COMMISSION ACTION FORM

SUBJECT: REVISION TO MAJOR SITE DEVELOPMENT PLAN FOR 2710-2810
BOBCAT DRIVE IN RINGGENBERG PARK SUBDIVISION 4TH
ADDITION

Attachment B-2 **PROPOSED MAJOR SITE DEVELOPMENT PLAN** **2710-2810 Bobcat Drive, Ringgenberg Park 4th Addition**

RE: Ringgenberg RM Master Plan Changes - Bobcat Drive Change
FOX Ref. No. 5099-08a.323

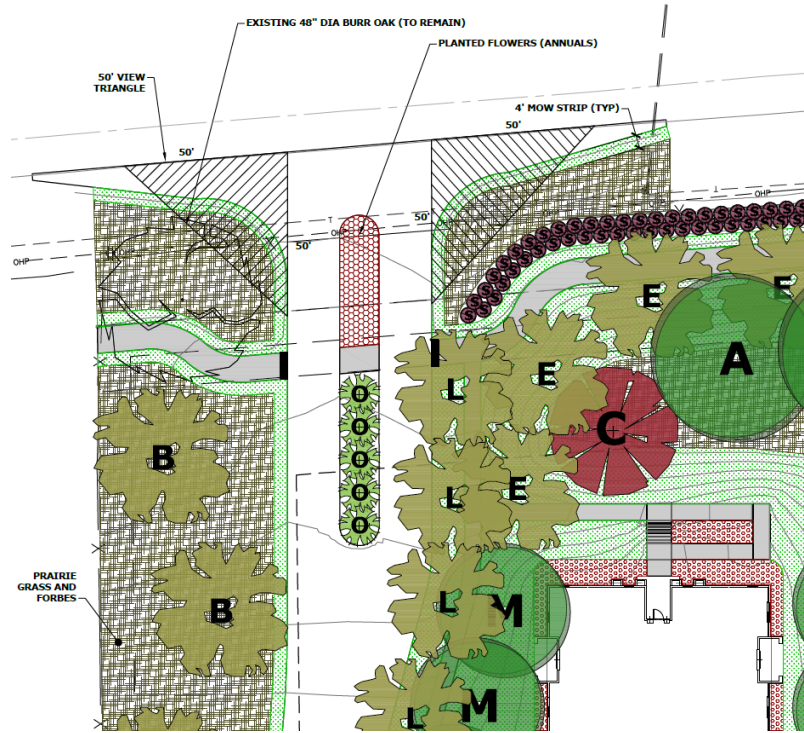
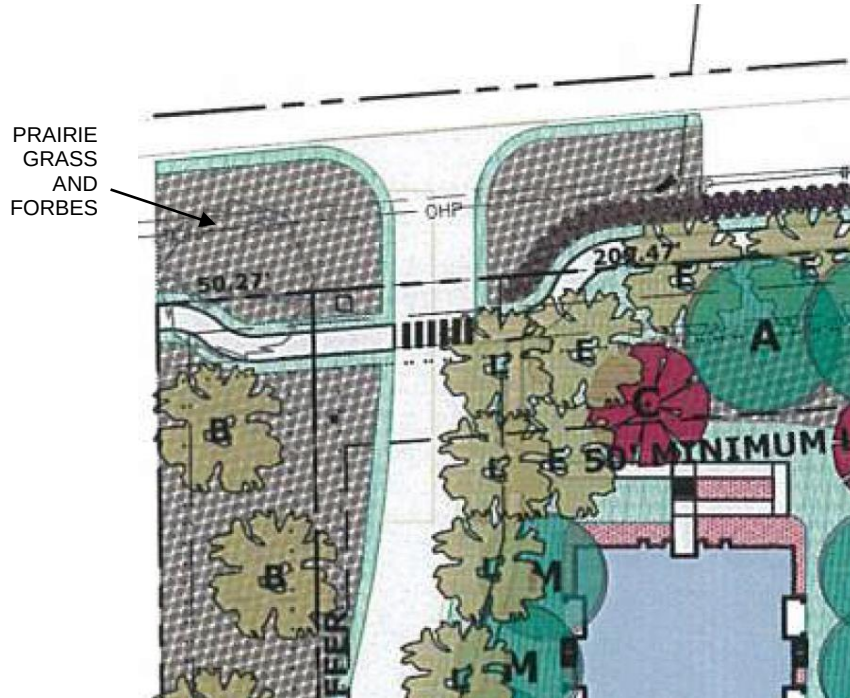
On the approved plan, Bobcat Drive is divided into two 16-foot wide lanes with a 12-foot wide median in the center for a distance of 70 feet south from the right-of-way line of Oakwood Road and 30 feet north into the right-of-way. The median would have been planted with annual flowers and other plants. The applicant proposes a change for this driveway segment to consist of a 26-foot wide pavement with no median, which is the same as the rest of Bobcat Drive to the south and east. The proposed change reflects how the driveway has already been constructed. The landscape plan includes prairie grasses and forbs extending on both sides of this pavement. For ease of comparison, a diagram is included that shows both options (Attachment B). The applicant has provided more detailed drawings and images of the proposed change and explanation of the reasons for the revisions, which accompany this report.

The applicant states that this change was made for several reasons. It is intended to improve fire access. Also, the Bobcat Drive entrance was changed to reduce the impact on a large 100+ year-old bur oak tree near the drive to the west. Additionally, the reduced pavement width also reduces storm water runoff and construction cost.

City of Ames staff notes that the divided entrance with two 16-foot wide lanes was accepted by the Fire Department, before it was presented to the Planning and Zoning Commission and City Council, because Bobcat Drive also has access from Cedar Lane to the east that is 26 feet wide. Staff agrees that locating pavement outside of the drip line of the oak tree will reduce potential impacts. While reduced paving will reduce storm water runoff, it is not significant in this case.

The change affects the appearance from the north approach to the site. The divided drive with annual flowers will be different than a drive with prairie plantings on both sides. Throughout the various reviews of the Ringgenberg Park project, the neighborhood to the north has emphasized the importance of the appearance of the development along Oakwood Road. This is one of the reasons the plan includes perimeter tree plantings and landscaping and to plant them with the initial phase of apartment development.

concluded that the proposed revision to the entrance of Bobcat Road from Oakwood Road is not inconsistent with this Design Standard for a Major Site Development Plan. The change affects the driveway landscaping, but does alter the general enhanced perimeter landscaping. **Therefore, it is the recommendation of the Department of Planning and Housing that the Planning and Zoning Commission adopt Alternative #1 to recommend that the City Council approve the proposed revision to the Major Site Development Plan for 2710-2810 Bobcat Drive in Ringgenberg Park Subdivision 4th Addition.**
